Addendum 02

PROJECT: New Castle CSC Turf Softball Field
2200 South Main Street
New Castle, Indiana 47362

PROJECT #: 26059.00

This addendum form is a part of the Contract Documents and modifies the Construction Documents dated October 3, 2026 with amendments and additions noted below.

SHEET NUMBER: **C1.1**

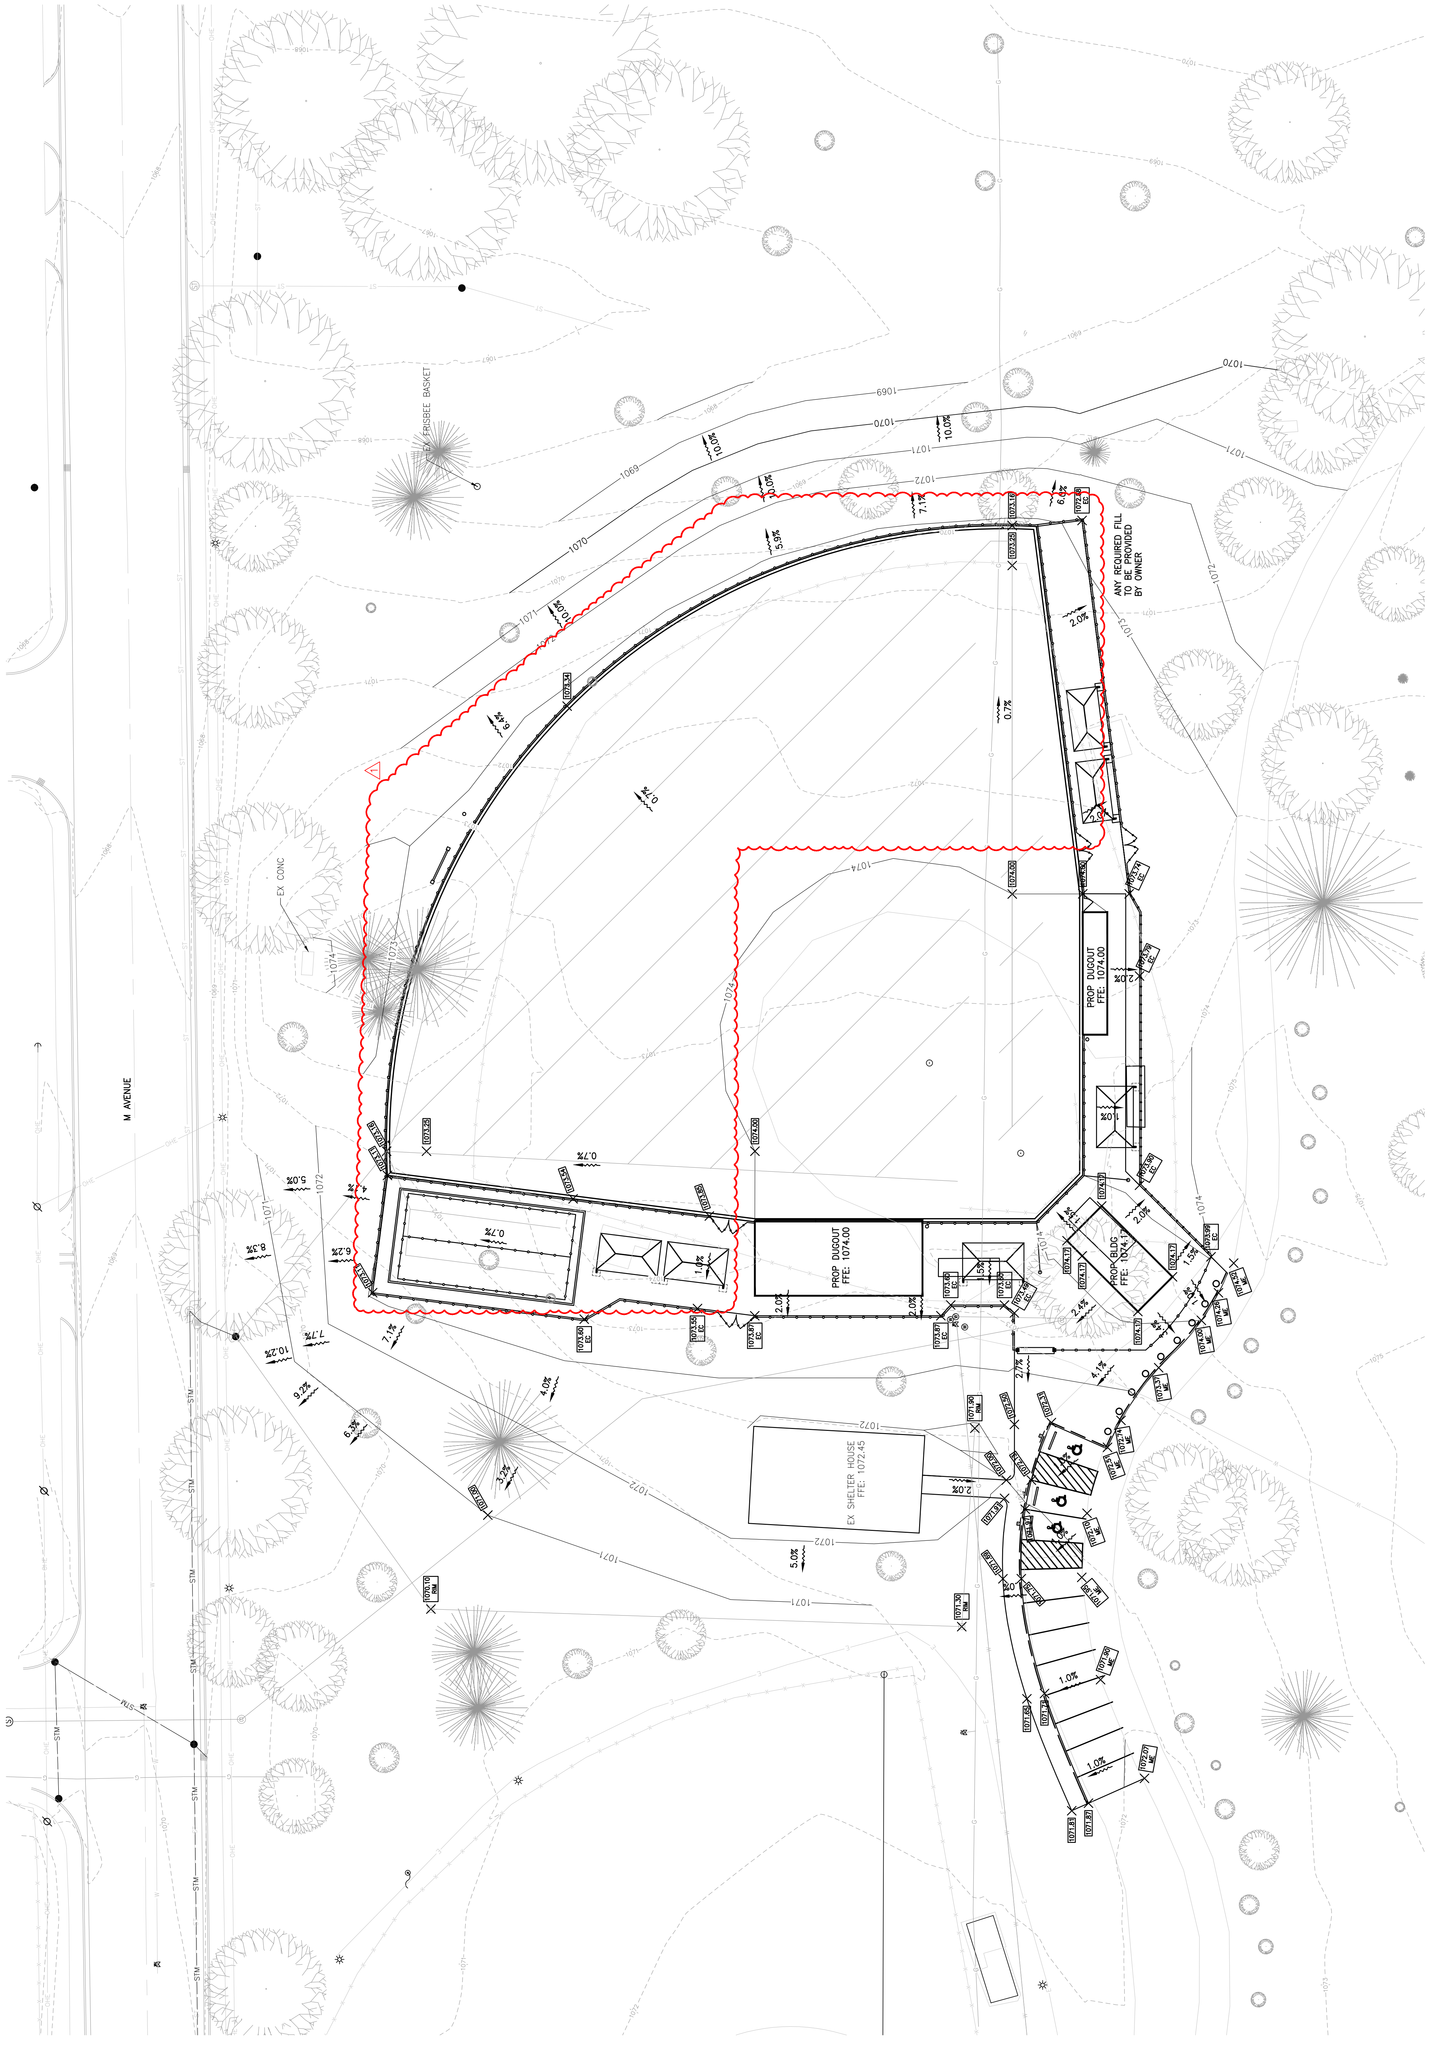
1. Drawing C1.1
    a. Modified grading in outfield to 0.7%
2. Drawing C1.2
    a. Added yard drain, underdrains, storm sewer, and sanitary sewer information

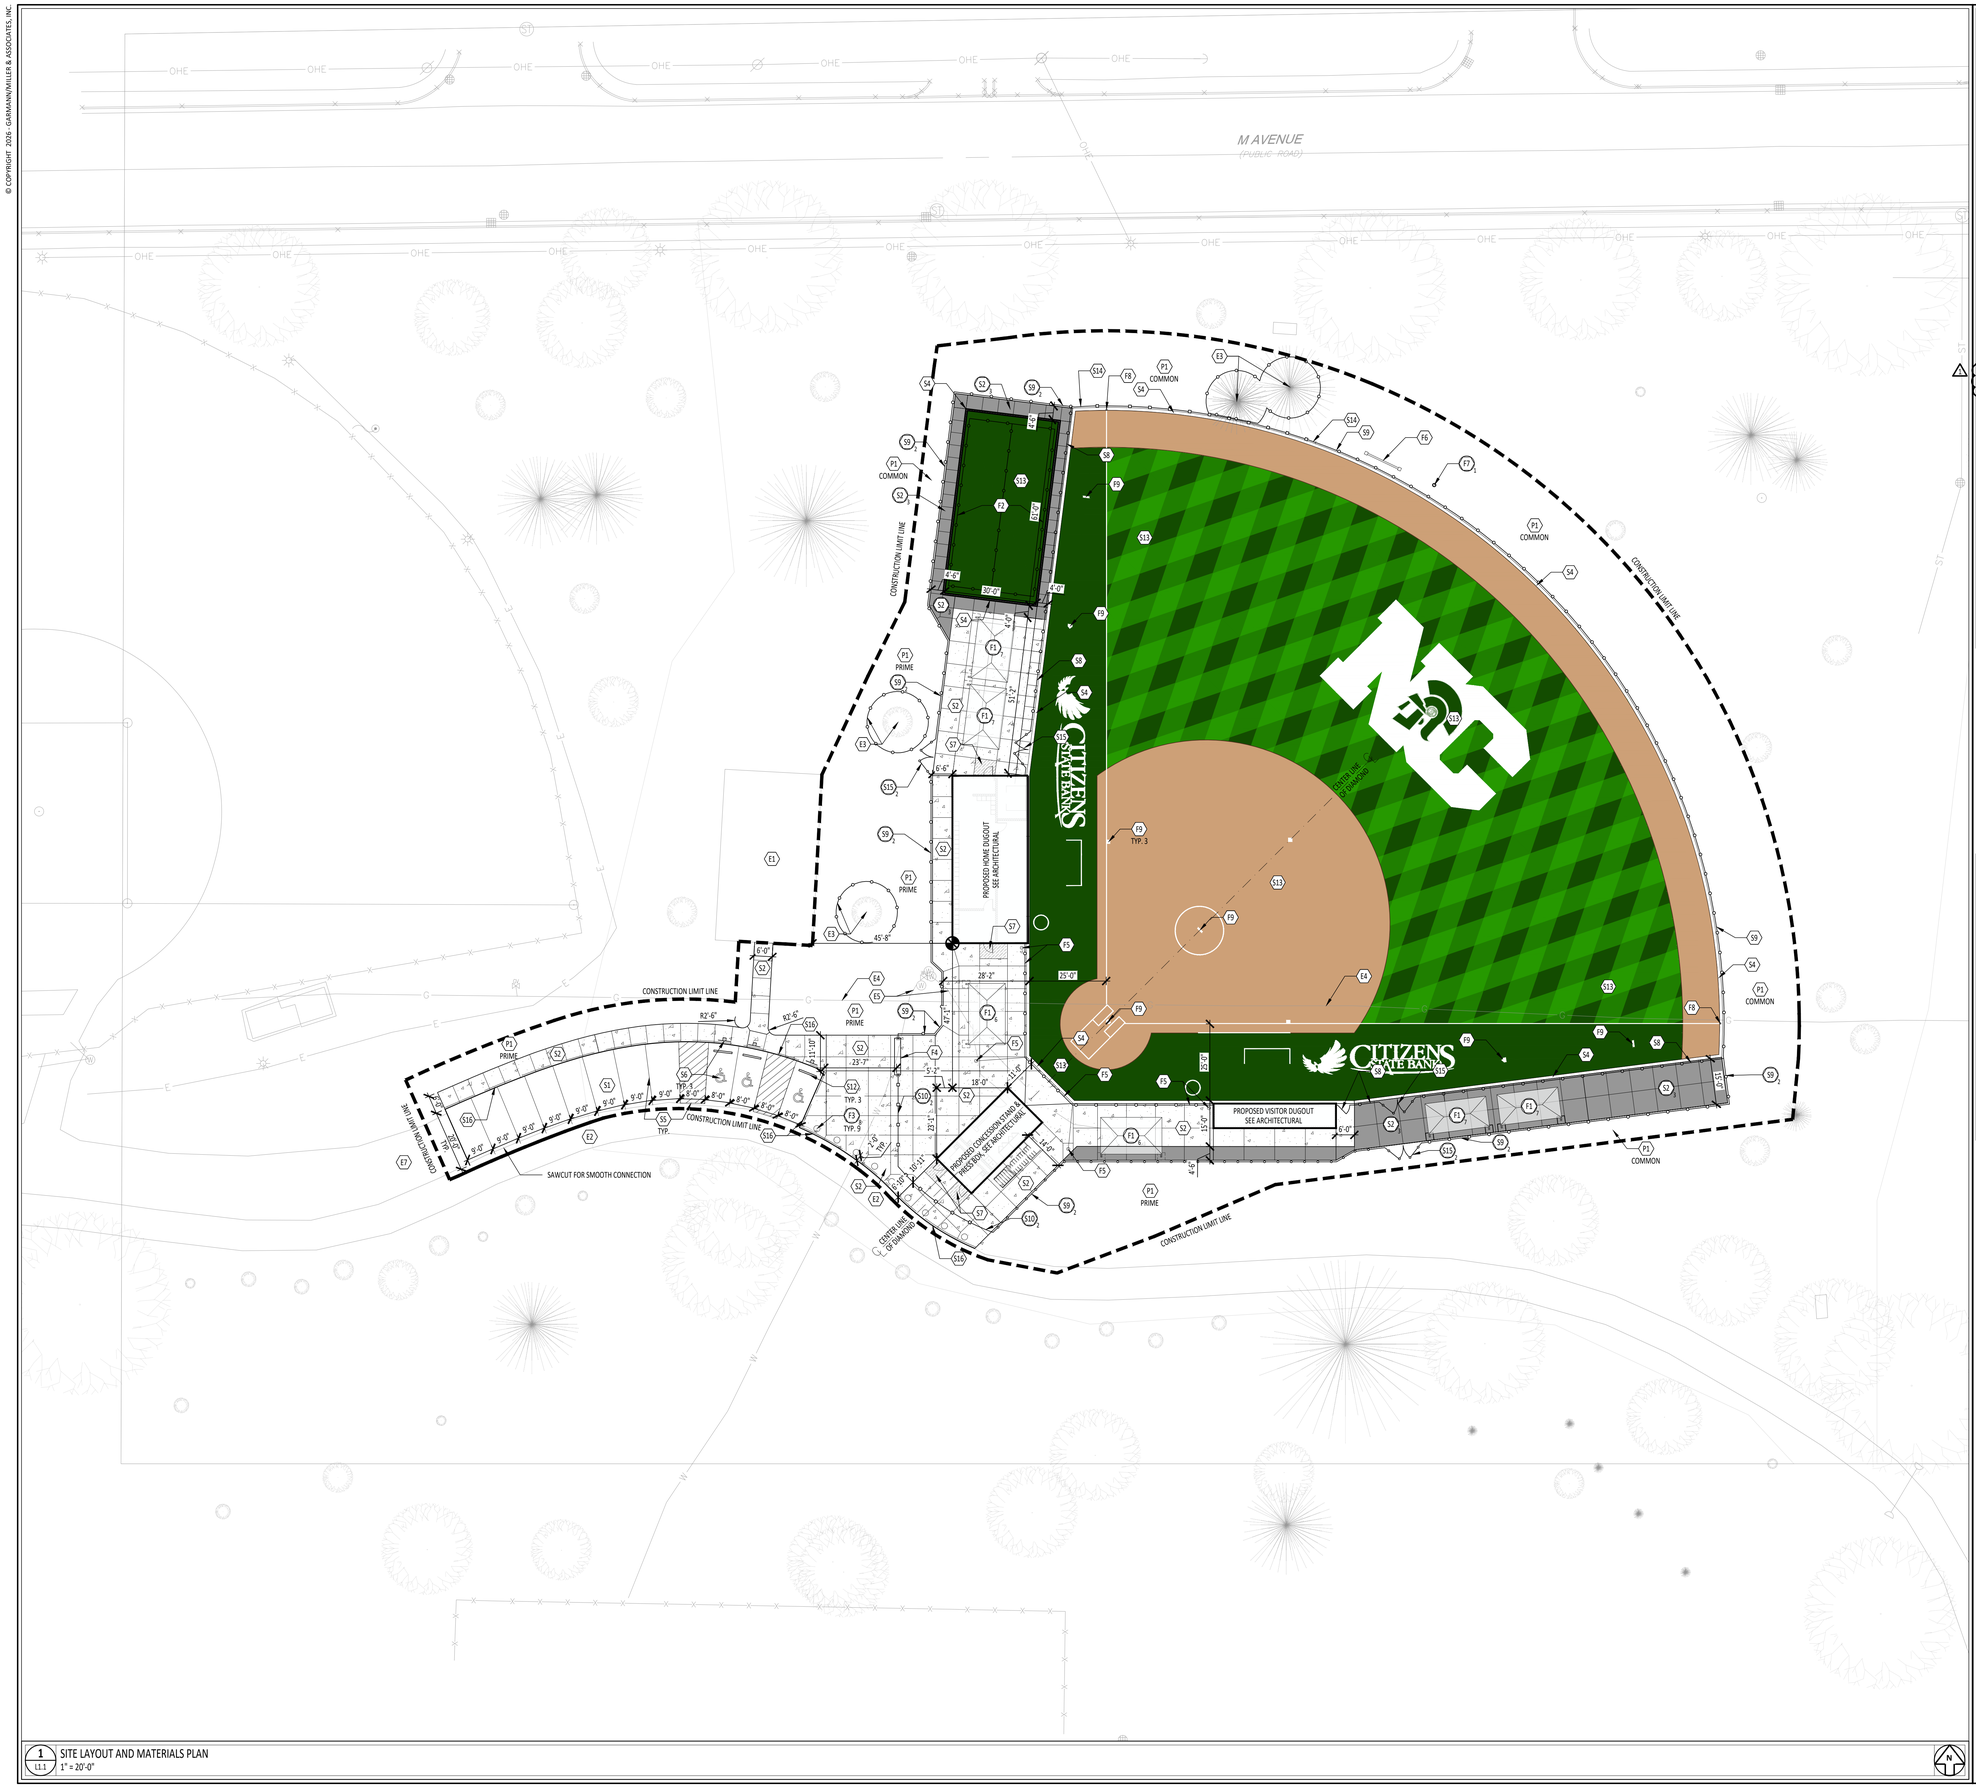
e. Added note to coordinate the upsizing of the water line with the city
3. Drawing C1.4
    a. Added underdrain in baseball field area detail
4. Drawing L1.1

L2.1

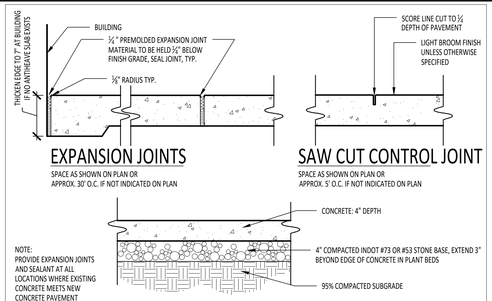
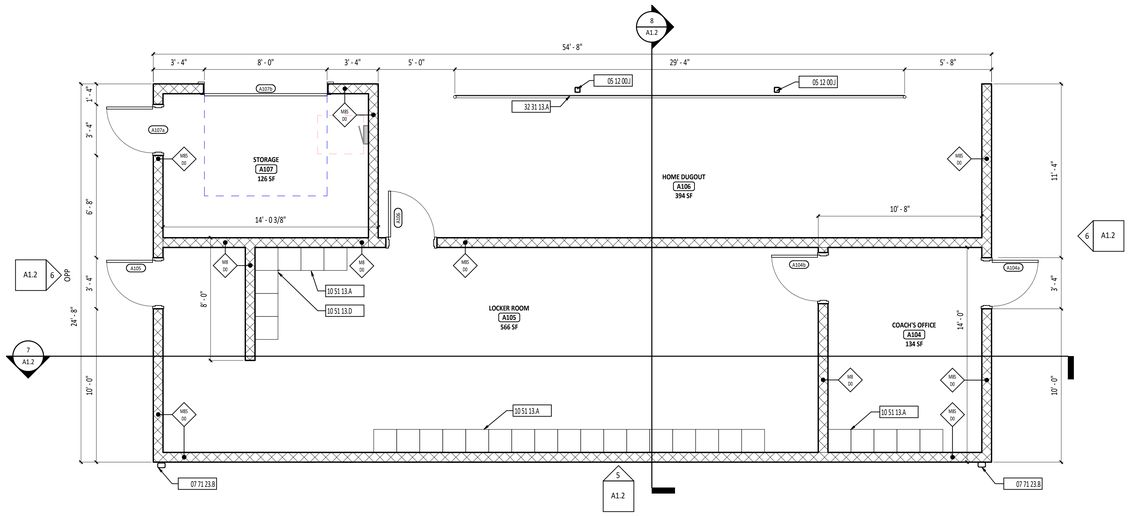
a. Added note for turf to be provided by owner and installed by contractor.
5. Drawing L2.1
    a. Added note for turf to be provided by owner and installed by contractor.

S13	SYNTHETIC TURF MATERIAL TO BE FURNISHED BY OWNER AND INSTALLED BY CONTRACTOR, SEE DETAIL 5/L2.1.
S14	~~4' HIGH VINYL COATED CHAINLINK FENCE, SEE SPECIFICATIONS~~
S15	12' WIDE DOUBLE-LEAF VINYL COATED CHAINLINK GATE, SEE DETAILS 12 & 15/L2.1
S16	FLUSH CONCRETE CURB, SEE DETAIL 6/L2.1
	SITE FURNISHINGS
F1	SINGLE CANTILEVER SHADE STRUCTURE, SEE DETAIL 18/L2.1 AND SPECIFICATIONS
F2	BATTING CAGE, SEE SPECIFICATIONS
F3	DECORATIVE SOFTBALL BOLLARDS, SEE DETAIL 17/L2.1
F4	ENTRY ARCHWAY, SEE ARCHITECTURAL DRAWINGS
F5	TIE-BACK NET BACKSTOP SYSTEM, SEE SPECIFICATIONS
F6	SCOREBOARD PROVIDED BY OWNER INSTALLED BY CONTRACTOR
F7	30' HT. FLAGPOLE, SEE DETAIL 11/L2.1 AND SPECIFICATIONS
F8	YELLOW FOUL POLE, SEE SPECIFICATIONS
F9	BASE PLATES AND PITCHER'S BLOCK TO BE PROVIDED BY MOTZ
	PLANTING
P1	SEEDED LAWN

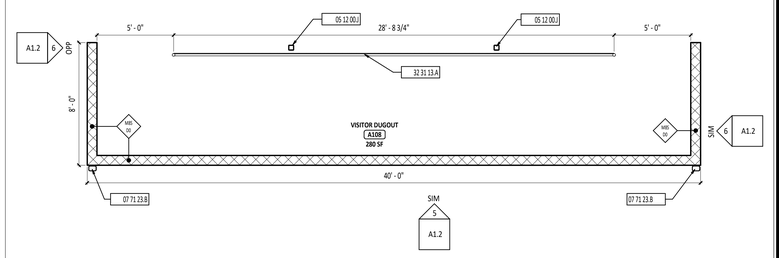
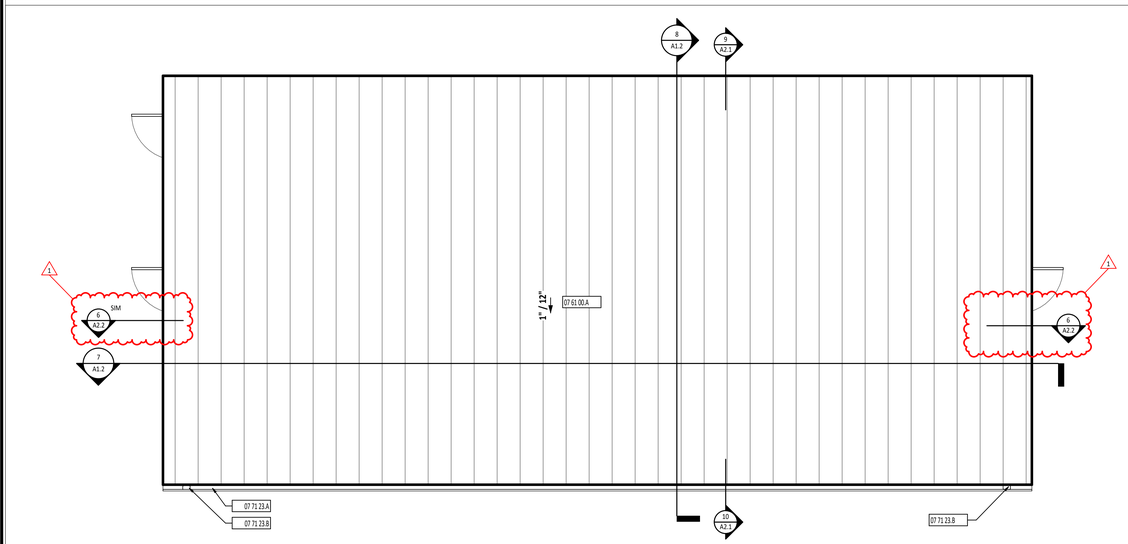
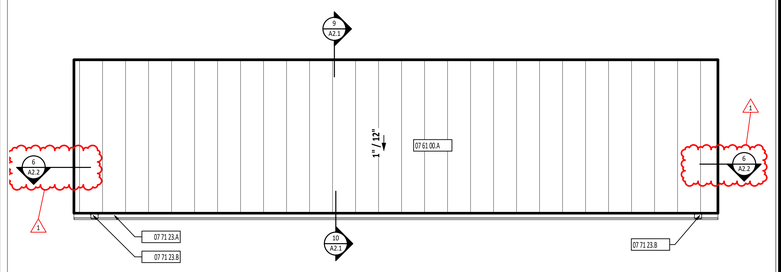
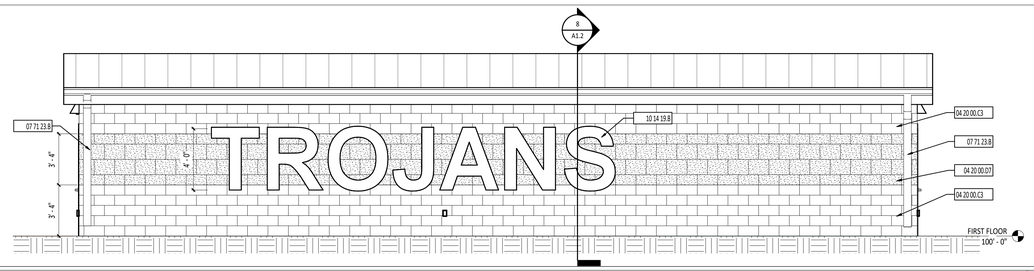
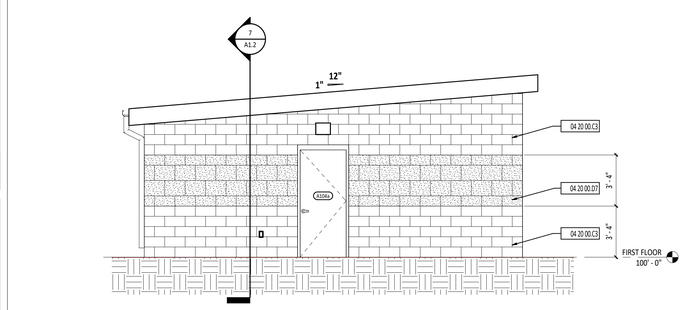
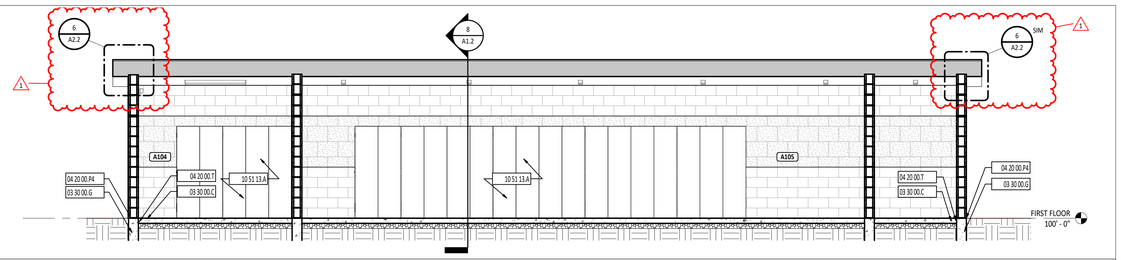
6. Drawing A1.2
    a. Added section detail callouts
7. Drawing A2.2
    a. Added section details
8. Drawing A9.1
    a. Modified the Metal Locker Schedule, Marking section to the correct locker listed on specs.

3 A9.1 **FIRST FLOOR PLAN - HOME DUGOUT**
1/8" = 1'-0"

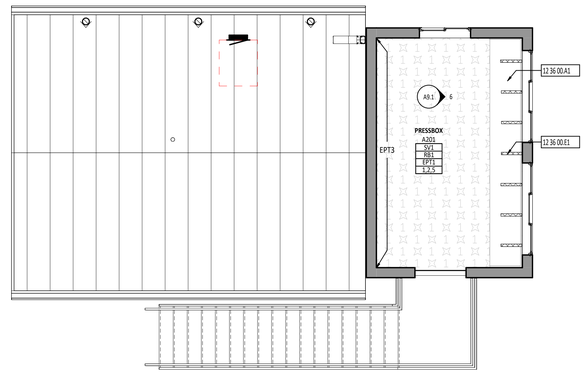
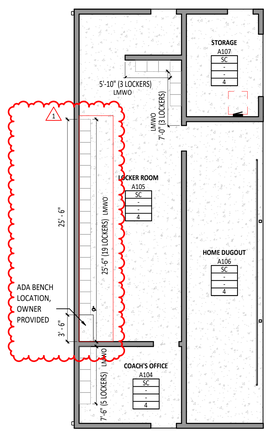
b. Modified the First-Floor Plan- Home Dugout floorplan to accommodate an ADA benching location.
9. Drawing P2.1
    a. Added RPBP and water meter. Added note to install in an accessible location from the plumbing chase access door.

PLUMBING PLANS, DETAILS, AND SCHEDULES

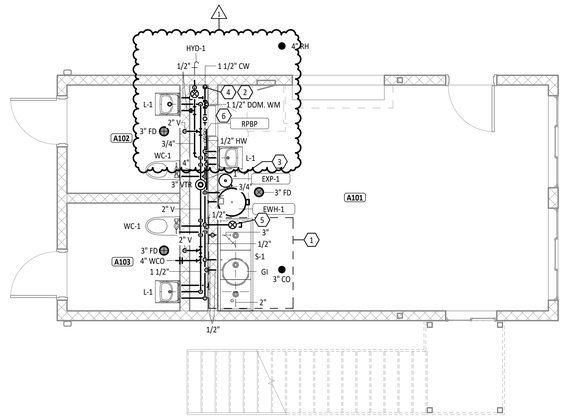
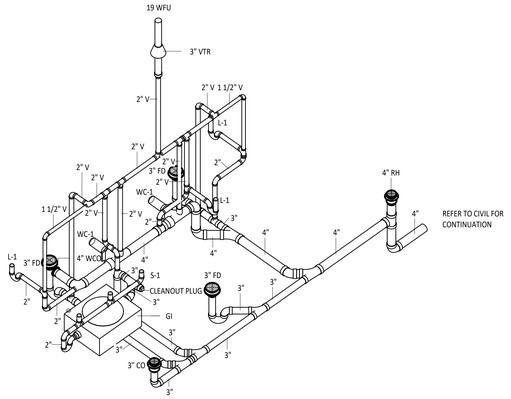
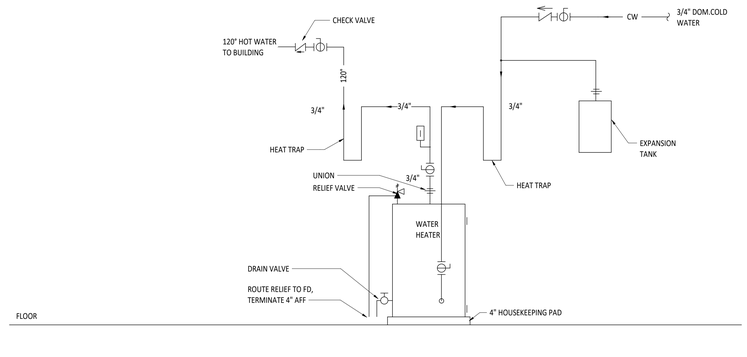
b. Modify domestic water piping to accommodate RPBP and water meter.
    c. Revised location of the water hammer arrestor so it is in an accessible location
